HISTORIC PRESERVATION BOARD STAFF REPORT

RE: Historic Preservation File No. 1844
6701 Collins Avenue – Deauville Beach Resort

Re: Deauville Hotel – Response to City's Traffic Comments

PROPOSED SITE PLAN- LEVEL 1
SCALE: 1" = 25'-0"

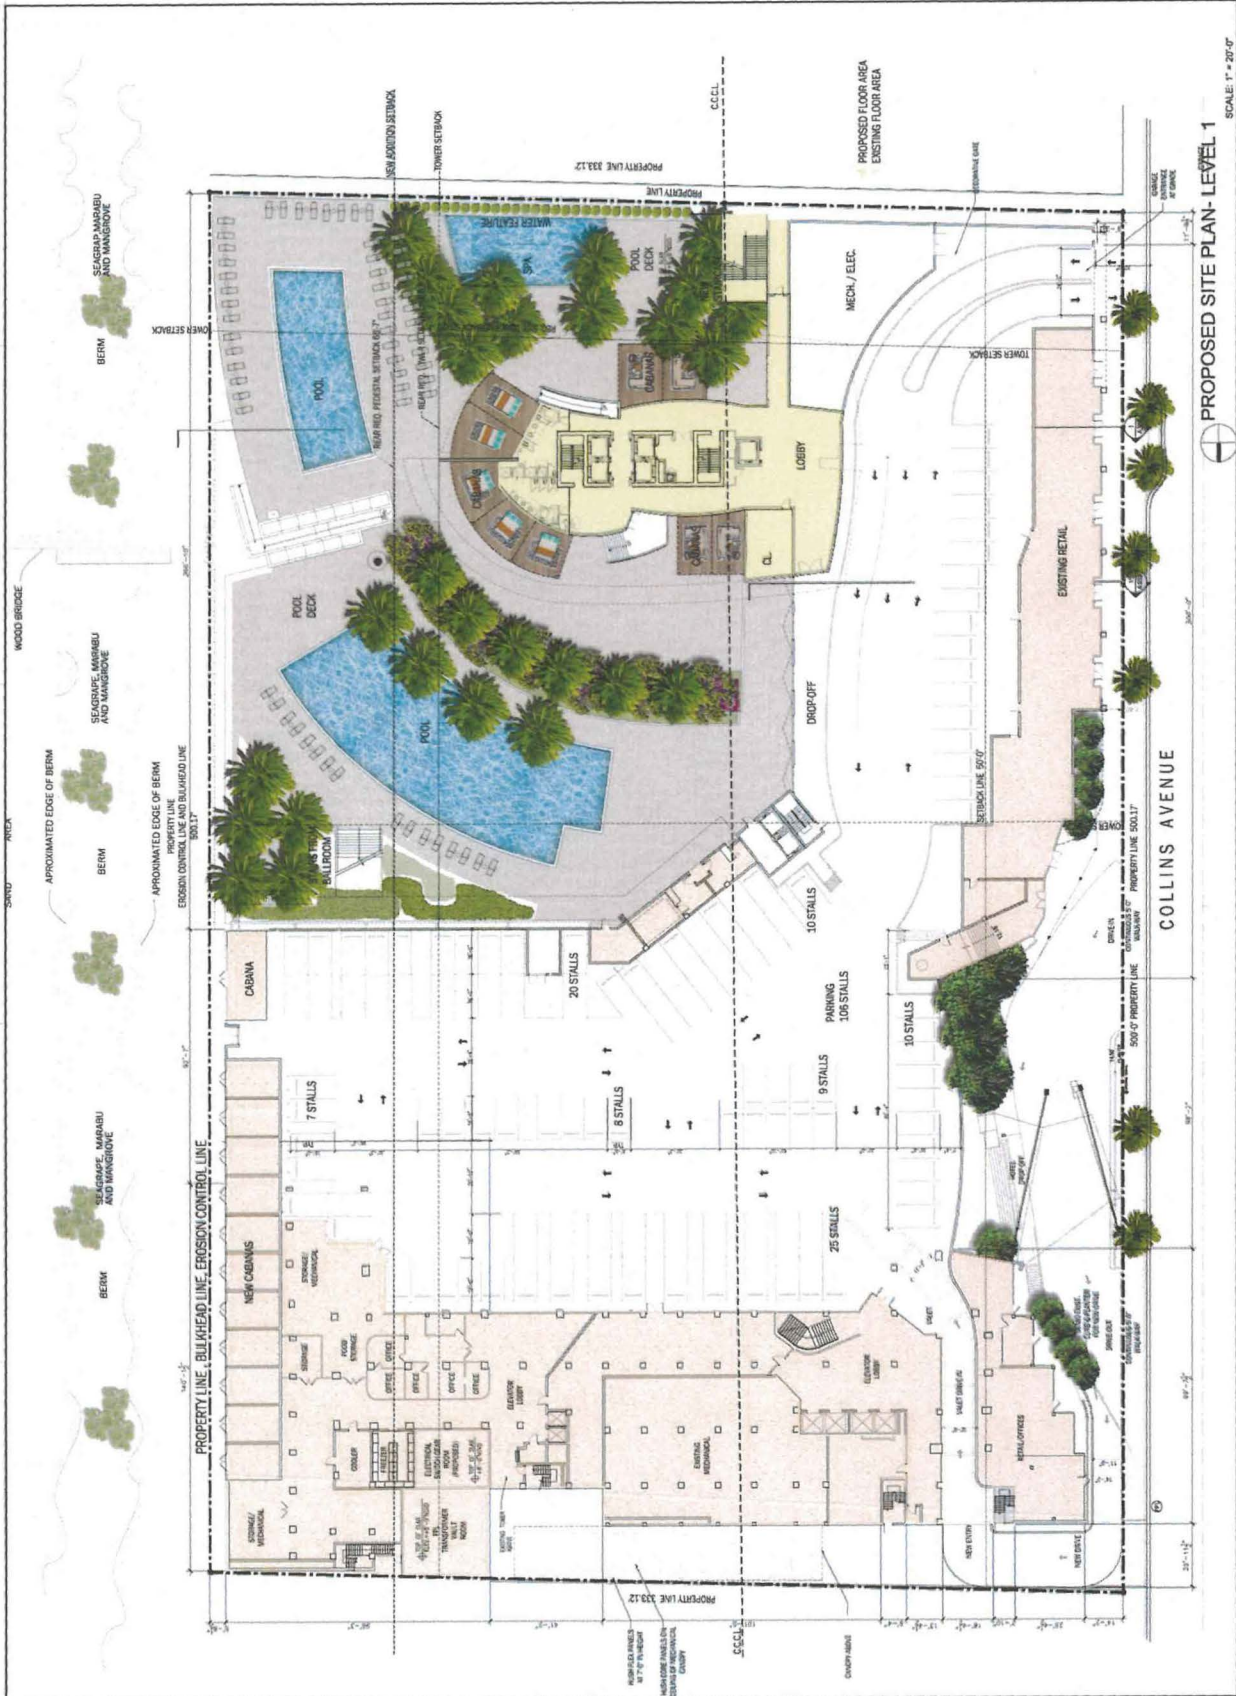
The plan shows, in addition to the main driveway on 67th and Collins, a driveway to the south of 67th and Collins (one-way entrance and one-way exit), as well as traffic entering the site through a one-way driveway provided to the north of the intersection of 67th and Collins. Only the analysis for the driveway on 67th and Collins was provided as part of the traffic report.

Comment 4: Driveway at 67th and Collins. In a meeting with FDOT it was indicated that the study needs to look into better defining the entrance of vehicles from Collins perhaps by narrowing the existing width of the driveway entrance to make the pedestrian crossing safer as the driveway intersects the sidewalk. That condition also applies for the exiting portion of the driveway heading north onto Collins. If the driveway was left as is, there is the high probability that it could be used as a two-lane driveway creating a hazard condition for pedestrians using the sidewalk on Collins in front of the site.

Response 3: Analysis of the south driveway is included in Attachment C. The inbound-only connection into the new on-site parking area has been widened in order to adequately accommodate the turning paths of automobile traffic (P-Design Vehicle), including large utility vehicles, in a safe manner, per AASHTO standards. The attached (Attachment D) site plan shows the ingress into the new on-site parking area with the extra widened access aisle.

- Reverse the circular driveway to a south-to-north direction.
- Incorporate the suggested pavement markings depicted in Attachment E for better channelization at the entrance and exit of the circular driveway.
